REQUEST FOR QUALIFICATIONS AND PROPOSALS FOR DURANT AVENUE & WOOSTER STREET SIDEWALK IMPROVEMENTS: #2024-005

Addendum #2

January 26, 2024

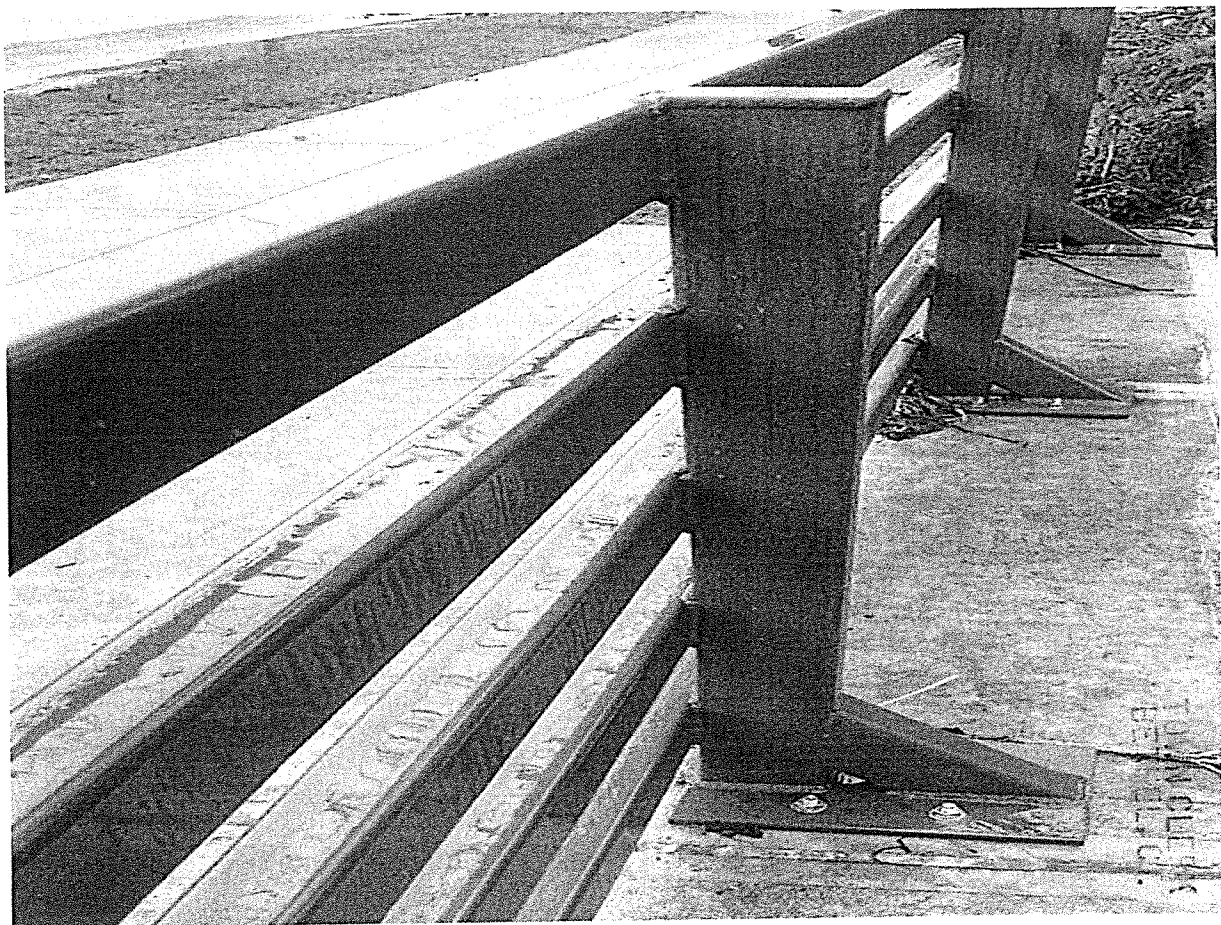
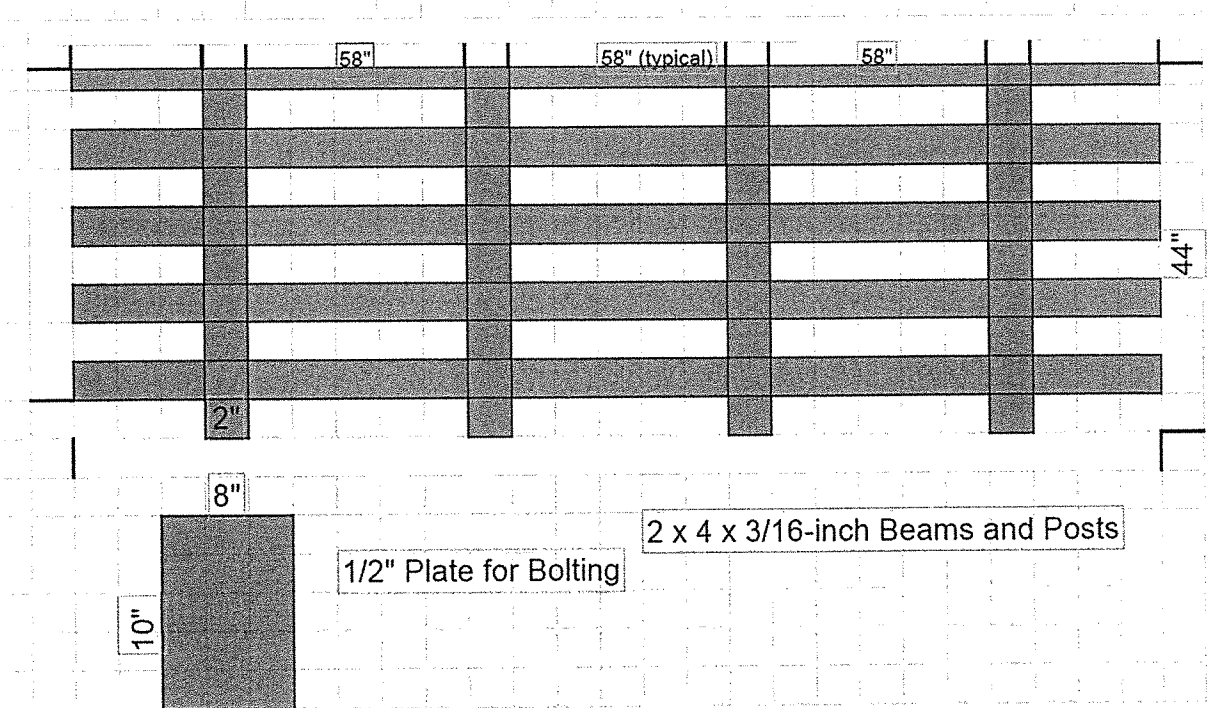
What are the specifications for the 42" high handrail indicated in the plans on Drawing Sheet C-6?

"As the handrail is not mentioned in the Specifications provided in the bid package, please provide the following: We request that bidders provide a proposed design/specification for a metal handrail securely bolted to a poured concrete foundation, with the handrail at least 42 inches high and the foundation a minimum of an 8-inch-thick pour.

For reference, the specification should be in accordance with Section 9.14, Metal Handrail, of CTDOT FORM 818, *Standard Specifications for Roads, Bridges, Facilities and Incidental Construction* (latest version). Preferably, we are looking for something equivalent to this 44-inch-high handrail, **shown in the sketch and photo on page 2 of this addendum.**

However, the Town will consider other handrail designs and materials proposed by bidders, based on whether they are deemed to be equivalent (based on such factors as ADA compliance, structural integrity, etc.).
